6/20/91
TS-SSC 91-127

To: Wally Zimmerman
From: Jim Strait
Subject: Change in shim for long 50 mm outer coil mold

Figure 1

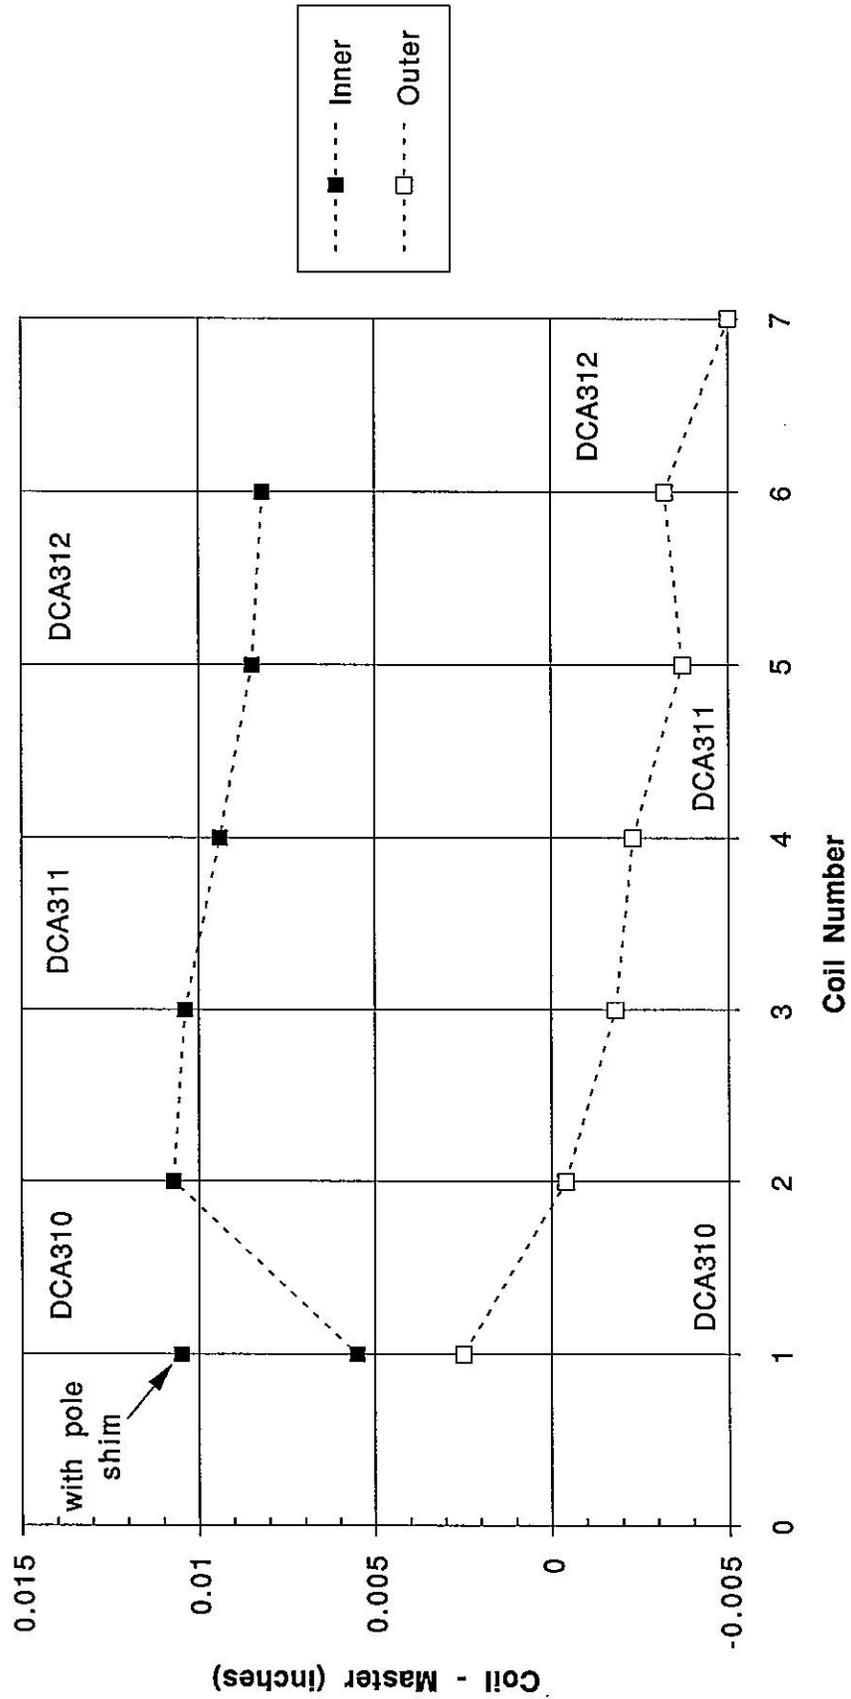
Over the course of long coil production, the average size of both the inner and the outer coils has become progressively smaller. Fig. 1 and Table I shows the average coil size versus coil number and indicates which coils belong to which magnet. Between inner coils 1 and 2 (15M-50-1001 and -1002) the mold shim was increased by 5 mils and between outer coils 1 and 2 the outer mold shim was decreased 3 mils. Since then the mold conditions have remained nominally constant, but the inner coil size has decreased about 2.5 mils and the outer coil size has decreased almost 5 mils. The cause of this decrease is not known.

The shim under the stop bar on the long 50 mm magnet outer mold should be increased from 7 mils to 10 mils starting with the next coil (15M-50-2008 for DCA313). This will give a total thickness of the stop bar plus shim of 0.250 inch.

Figure 2

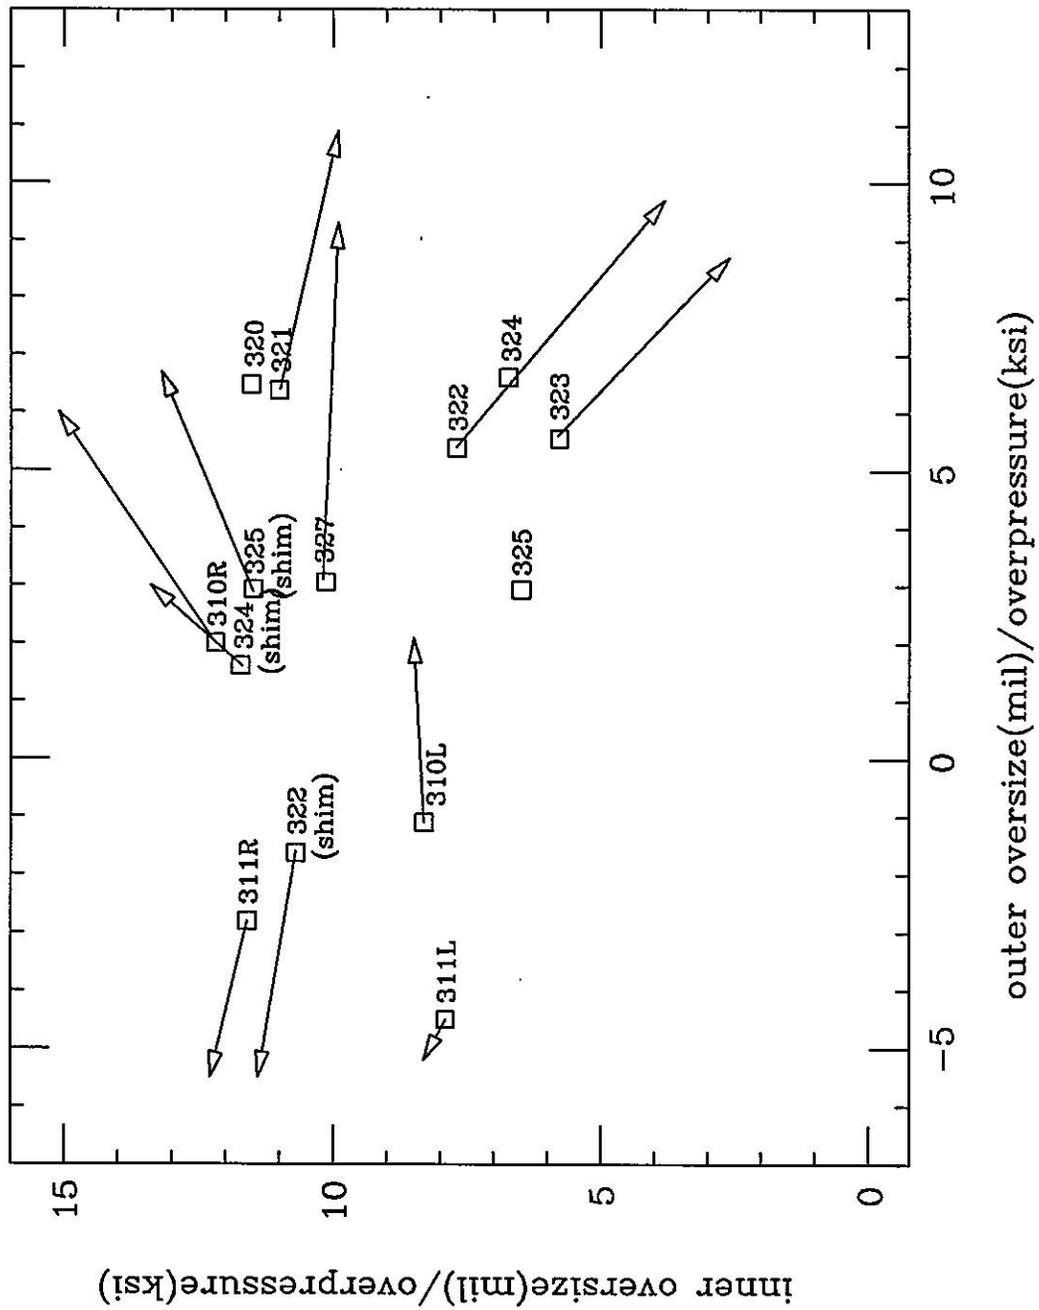
Based on experience with the short 50 mm magnets and the first two long 50 mm magnets, the target size range for inner coils is approximately +7 to +11 mils relative to the master and for outer coils is approximately -4 to 0 mils relative to the master. Fig. 2 ("Wake plot[1]") summarizes the size and preload data for all 50 mm magnets made so far. The position of the square for each magnet gives the size relative to the master of the inner and outer coils at the strain gauge pack. The length of the arrow in each direction gives the difference between the measured coil prestress and the center of the target band: 10 kpsi in the inner coil and 8 kpsi in the outer coil. If the arrow points to the right or up, then the outer or inner prestress is above the center of the target band and therefore the outer or inner coil is must be larger than the center of the target coil size band. In the absence of measurement errors, the arrows should all point away from a common point which corresponds to "perfect" inner and outer coil sizes. From this plot it seems that the target inner coil size is about +9 mils and the target outer coil size is about -2 mils. A band of ± 2 mils about these gives the target ranges quoted above.

The most recent inner coils still lie within the target range, so no inner mold shim change is needed at this time. However, if the trend towards smaller coil sizes continues, the mold cavity may have to be increased later. The most recent outer coil (15M-50-2007) is 1 mil smaller than the lower bound and the two previous coils (2005 and 2006) are near the bottom of the target range. The 3 mil increase in mold cavity should put the next outer coil at or a little above the center of the target range.
